U.S. DEPARTMENT OF COMMERCE
Office of Inspector General

***National Oceanic and
Atmospheric Administration***

***Audit of the Joint Polar Satellite System:
Challenges Must Be Met to Minimize
Gaps in Polar Environmental Satellite Data***

Final Report No. OIG-11-034-A
September 30, 2011

Figure 3. Potential Continuity Gaps in Afternoon Orbit

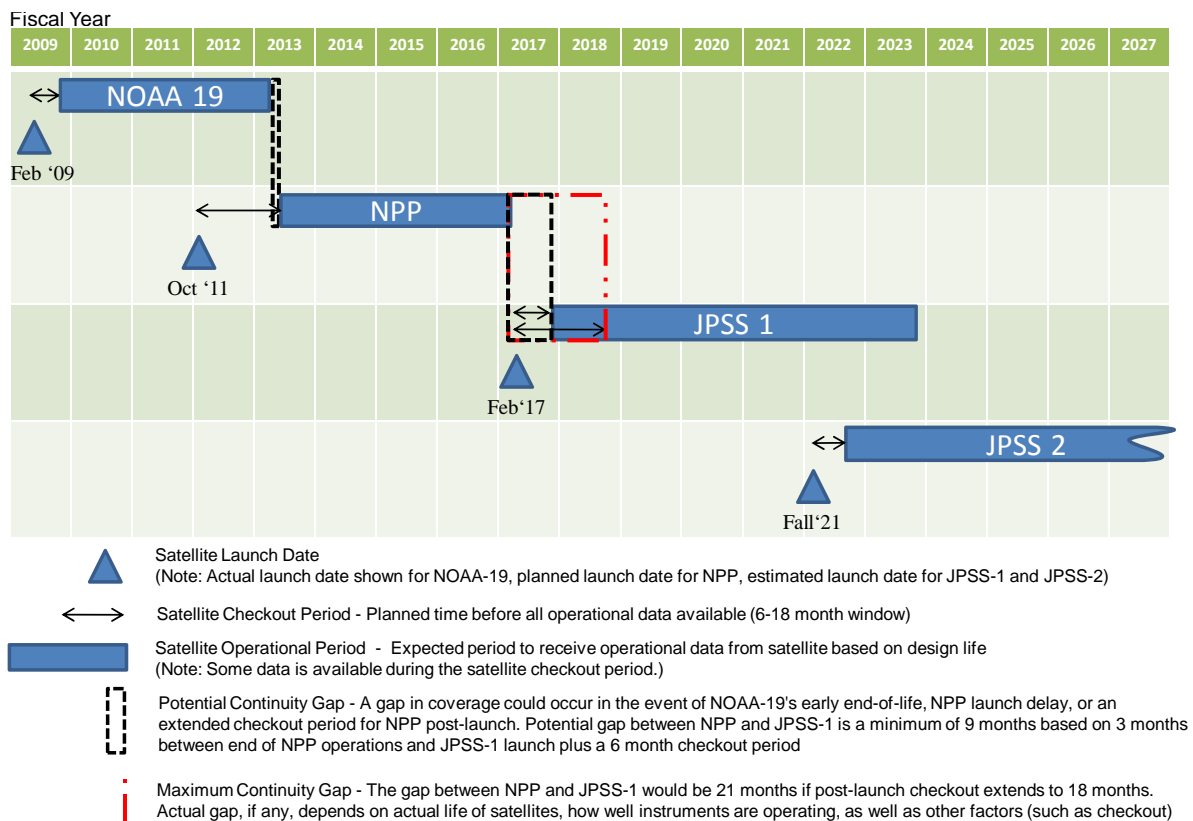
The program's current plans are to launch JPSS-1 in Quarter 1 FY 2017, rather than the February 2017 date listed in the report. There are several other locations in this report where the launch date is misstated. When this change is made, the expected gap using the OIG methodology (assuming NPP operates through its five-year design life and a 6-18 month Cal/Val period for JPSS-1) should be 6-18 months, rather than the 9-21 months the report states.

Page 8, Figure 3:

The figure should show the launch date of JPSS-1 as Quarter 1 FY 2017 and make the associated changes to the analysis of the length of the gap.

Page 8, Figure 3:

The existing Page 8, Figure 3 clarification should be replaced with the following:

We used a launch date of February 2017—rather than the program's current projected launch date in the first quarter FY 2017—due to continued budget uncertainty in FY 2012 and beyond, which could delay acquisition and development activities. NOAA officials told us a 6-month post-launch checkout period was necessary to achieve an interim operational capability to produce the data records that are most important for numerical weather prediction. Other

We have further substantiated our use of the February 2017 launch date for JPSS-1 under finding II. We have also updated finding III to reflect that ATMS has been transitioned from NPOESS to a NASA letter contract. The ATMS contract, like the other instrument contracts, will need to be finalized to completely resolve the transition issues.
